**TYPEs : MCB  
RCCB  
ISOLATOR**

Specification change of terminal screw for MCB, RCCB and ISOLATOR

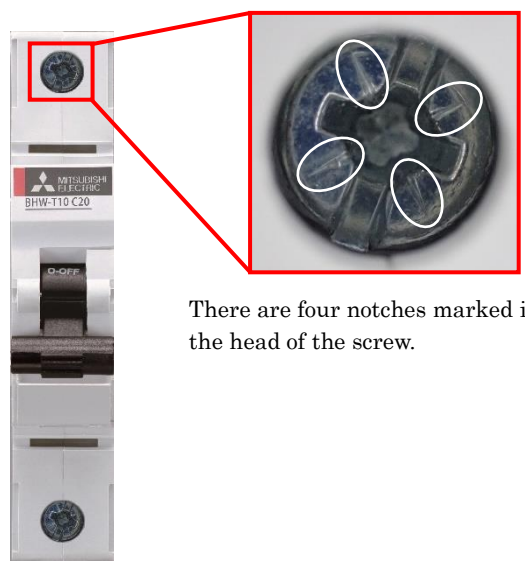
Specification change of terminal screw

Before change	After change
<p>Phillips cross-head screws</p>  <p>Ex. BHW-T10 (0.5 to 63A)</p>	<p>Pozidriv cross-head screws</p>  <p>There are four notches marked into the head of the screw.</p> <p>Ex. BHW-T10 (0.5 to 63A)</p>

\*Please use proper screwdrivers for the terminal screws.
